ADDENDUM NO. 8 TO PROJECT NO. 44578

CONSTRUCTION WORK - PLA
MAJOR BUILDING RENOVATIONS FOR THE
MANHATTAN FORENSIC
RELOCATION
MANHATTAN PSYCHIATRIC CENTER
600 EAST 125th STREET
WARDS ISLAND, NY 10035

September 29, 2015

SEVENTH FLOOR DEMOLITION AND WINDOW INSTALLATION PLAN
3/32" = 1'-0"

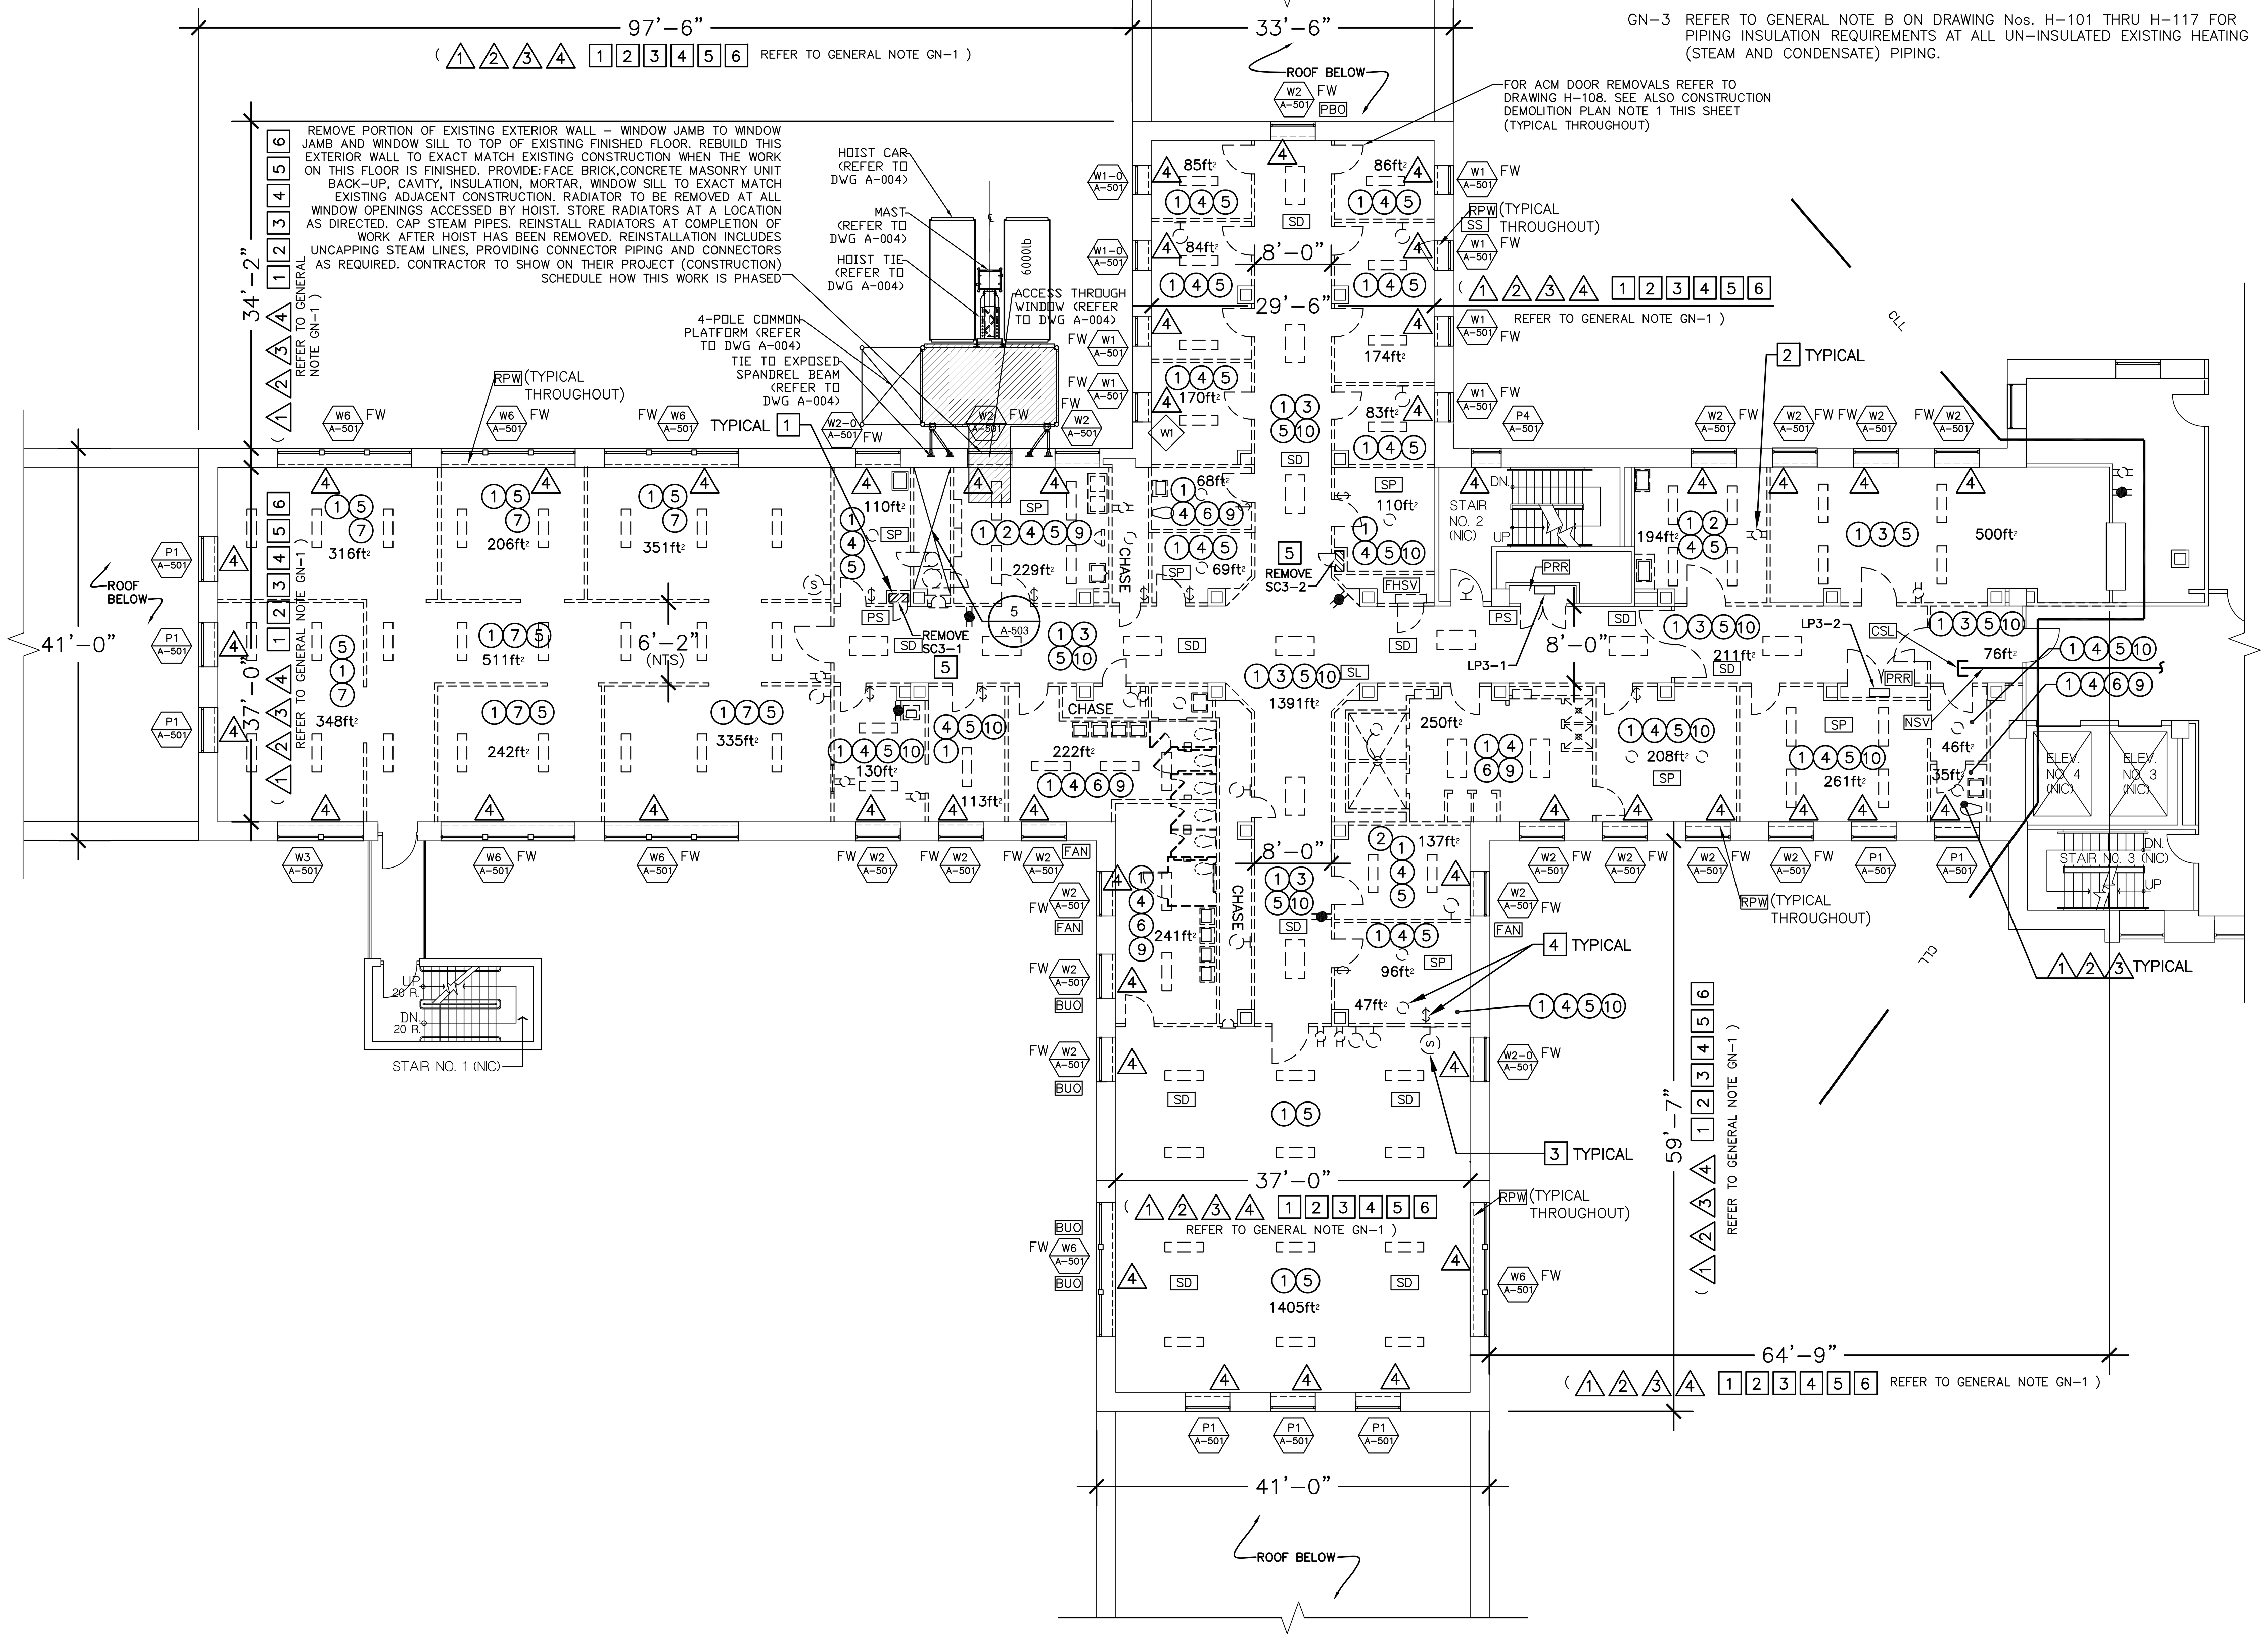
42. Revised Drawing (issued with Addendum #5) No. A-107-2:
    a. Revise Room names for 734A and 747A from “Passage“ to “Secure Corridor”.
    b. Delete detail tag 8/504-2 at column line H between 1 and 2, at column line 10 between N and O, and at column line 6 between M and N.

EIGHTH FLOOR DEMOLITION AND WINDOW INSTALLATION PLAN
3/32" = 1'-0"

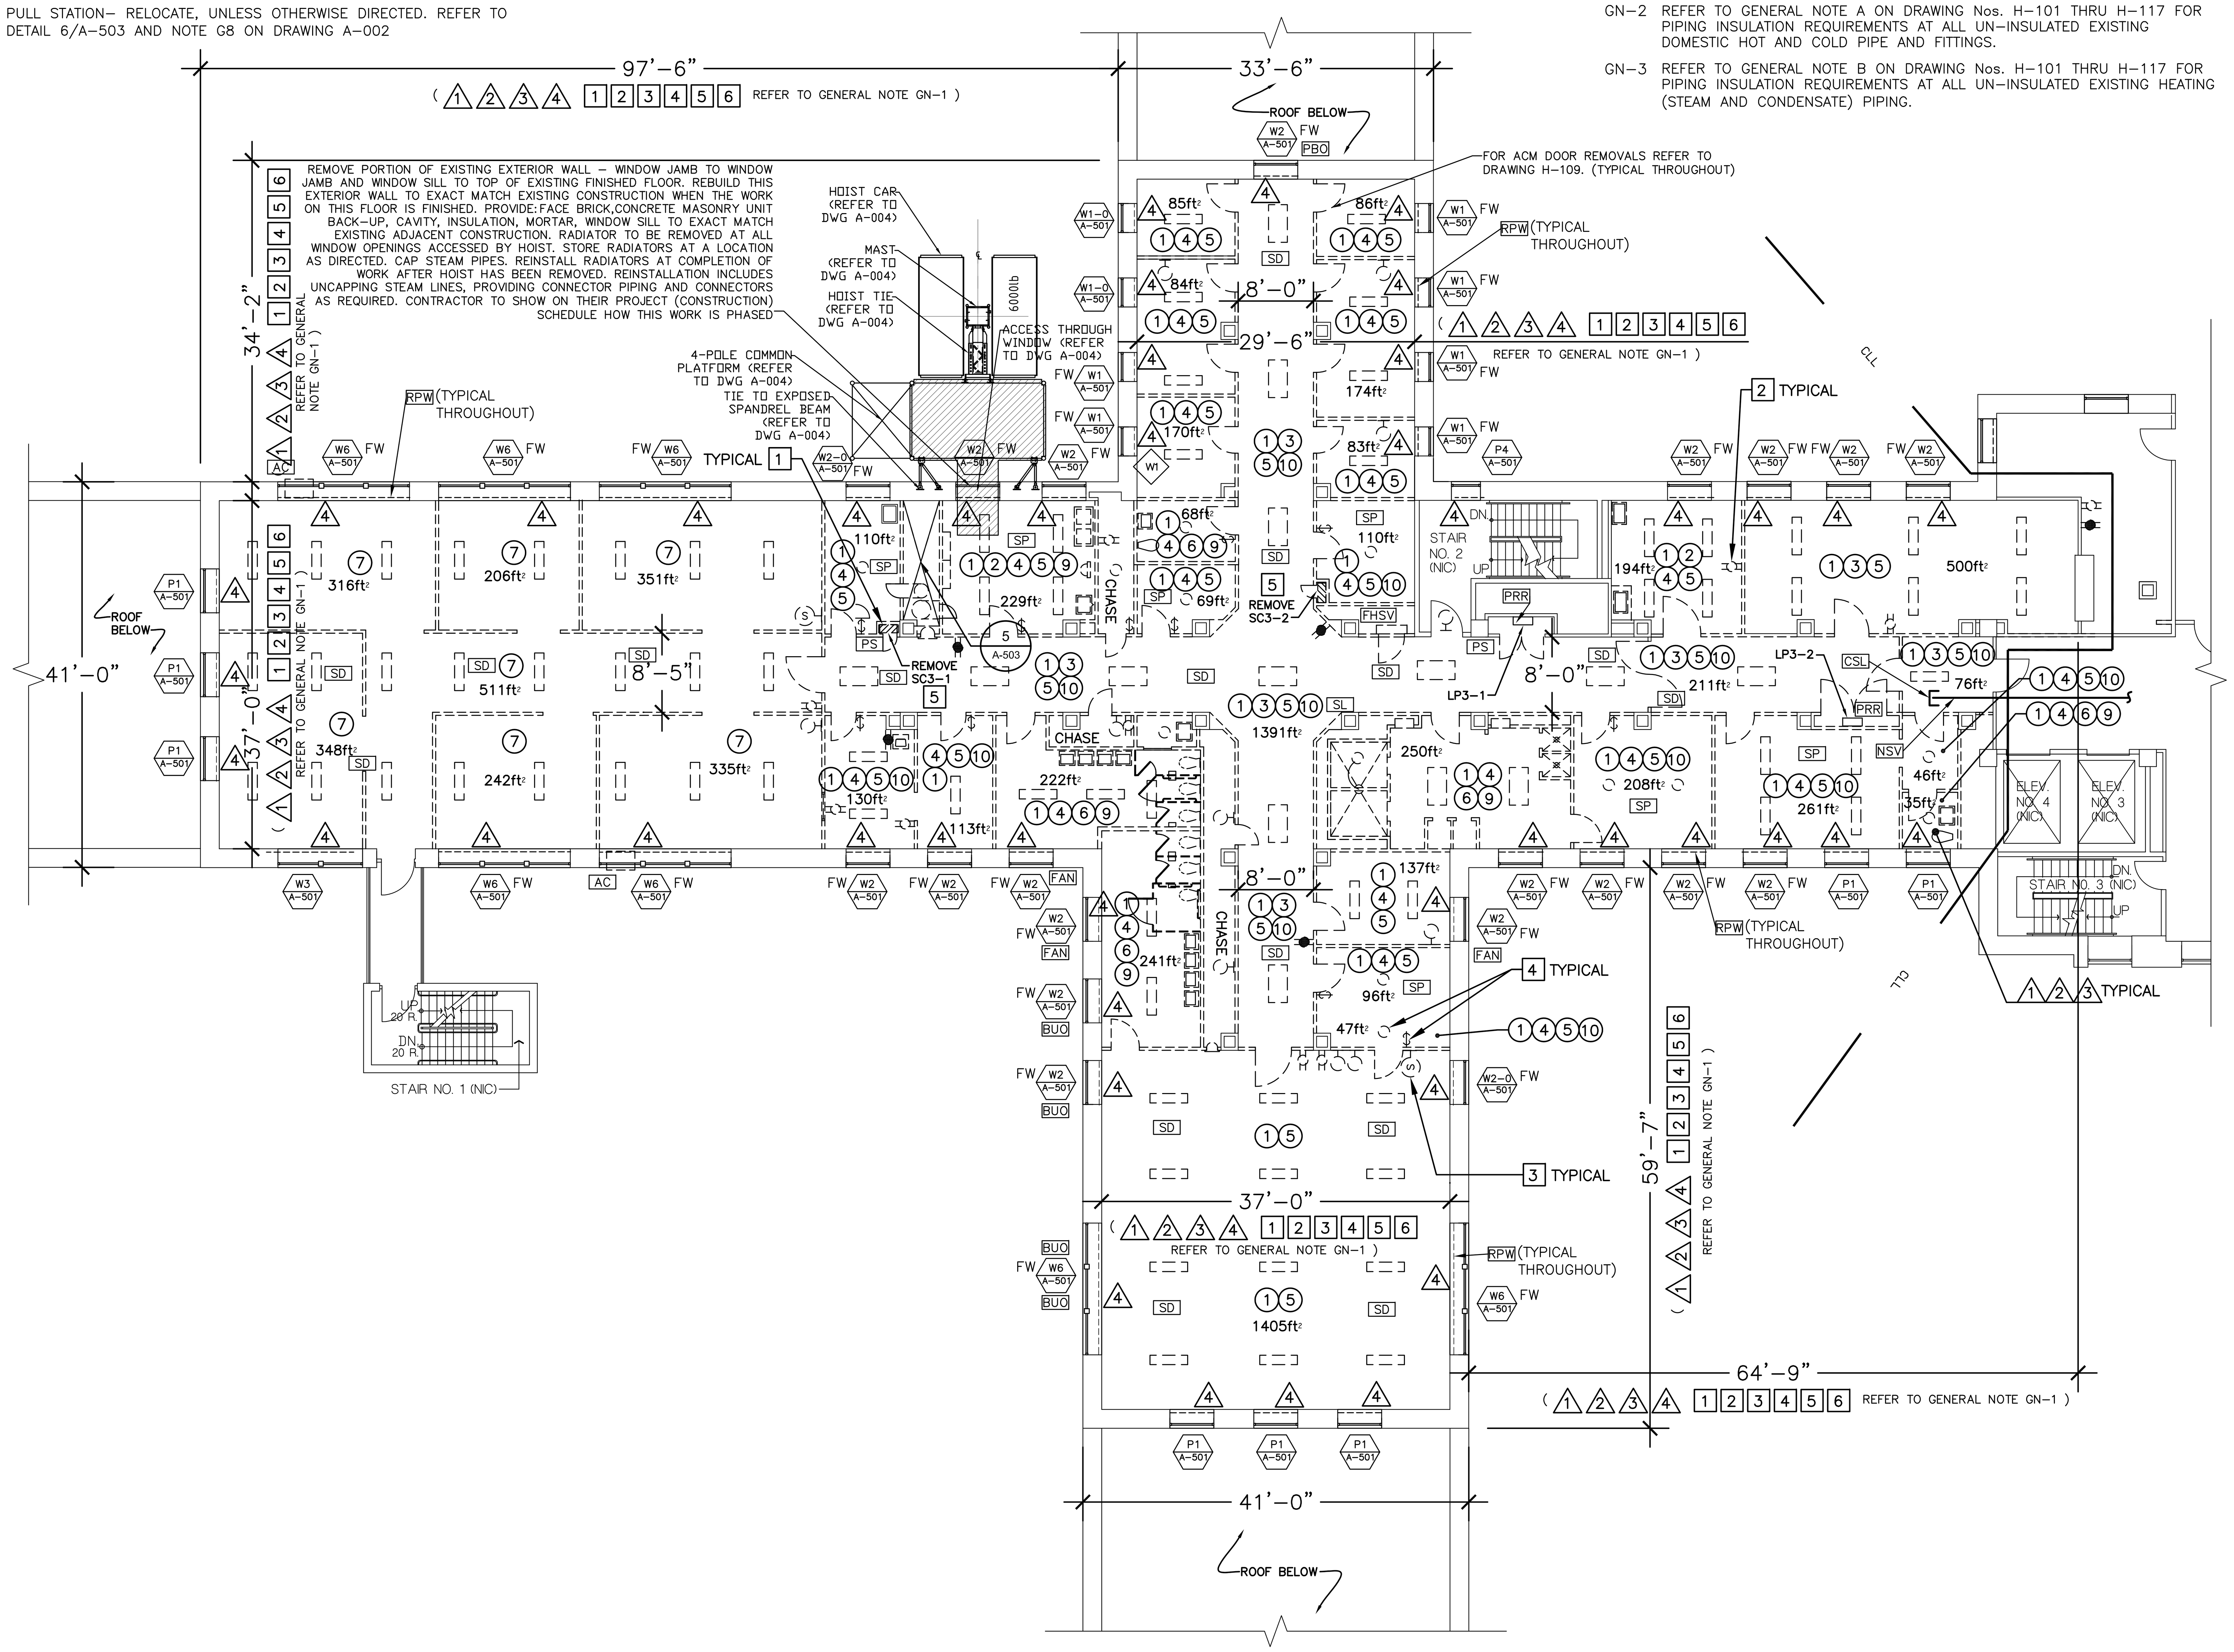
43. Revised Drawing (issued with Addendum #5) No. A-108-2:
    a. Revise Room names for 834A and 847A from “Passage“ to “Secure Corridor”.
    b. Delete detail tag 8/504-2 at column line H between 1 and 2, at column line 10 between N and O, and at column line 6 between M and N.

NINTH FLOOR DEMOLITION AND WINDOW INSTALLATION PLAN

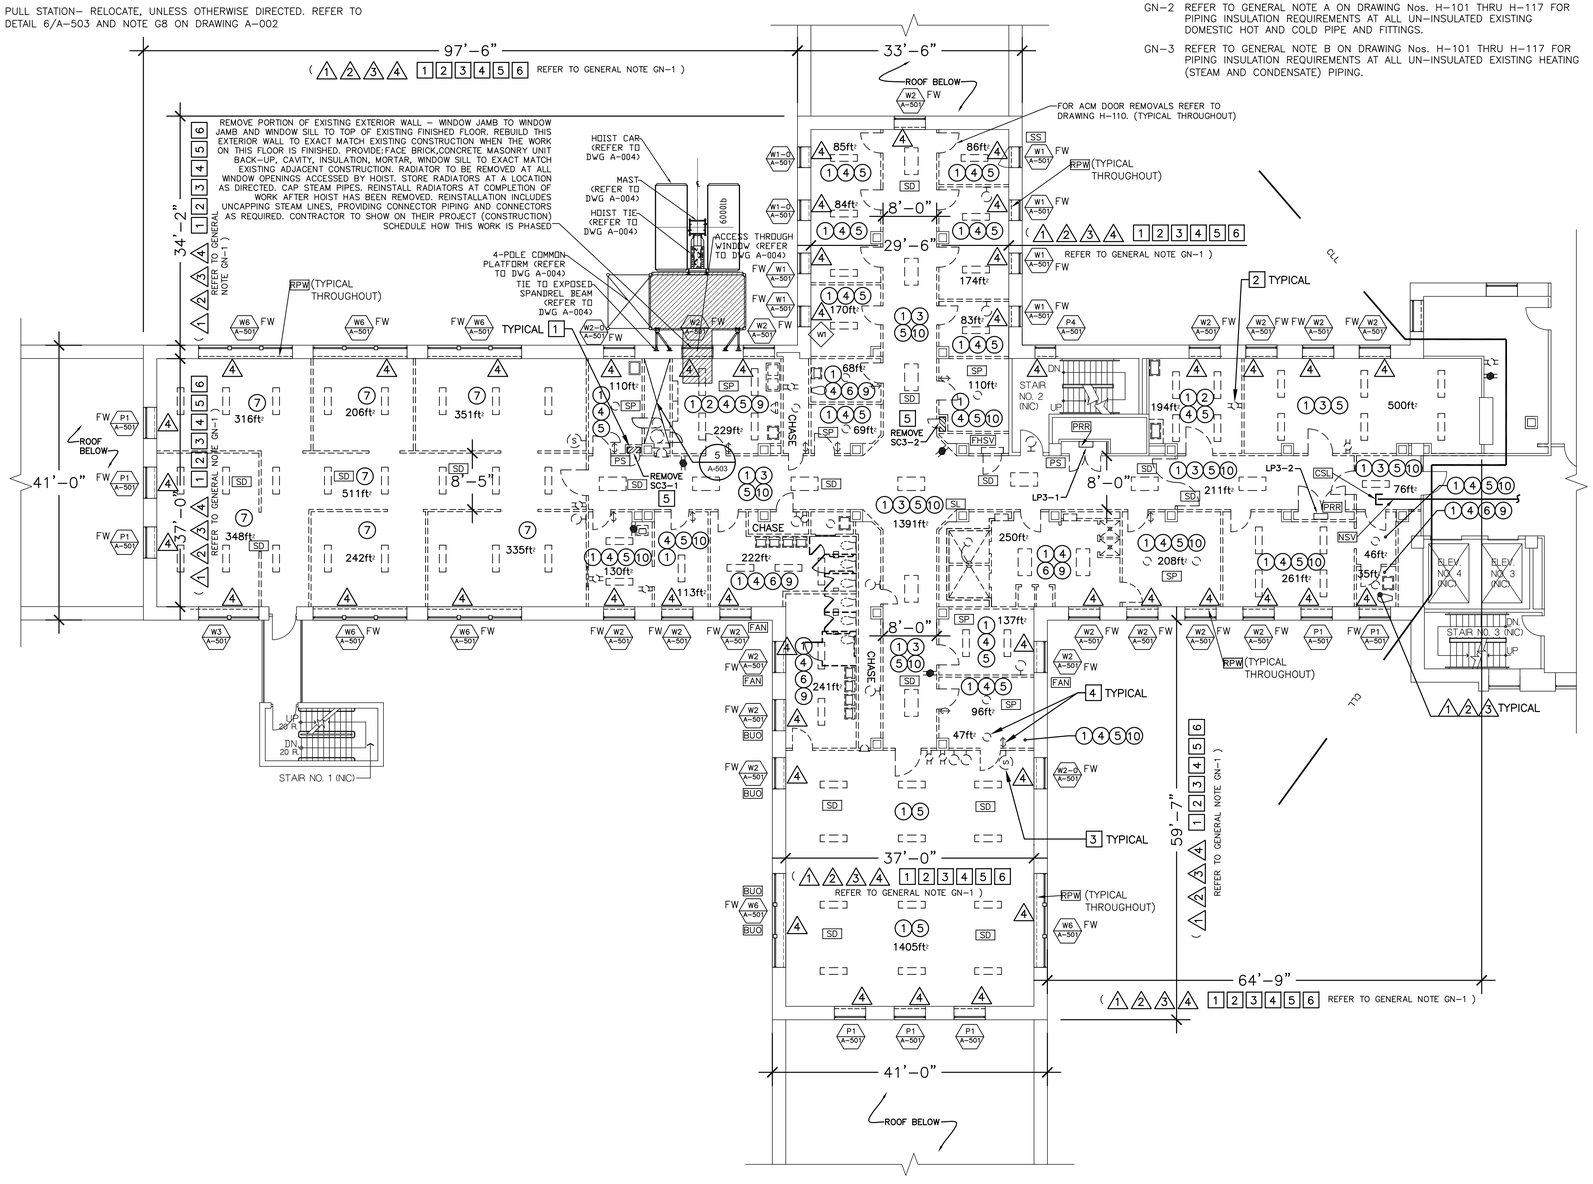
44. Revised Drawing (Addendum #5) No A-109-2:
    a. Revise Room names for 934A and 947A from “Passage“ to “Secure Corridor”.
    b. Delete detail tag 8/504-2 at column line H between 1 and 2, at column line 10 between N and O, and at column line 6 between M and N.
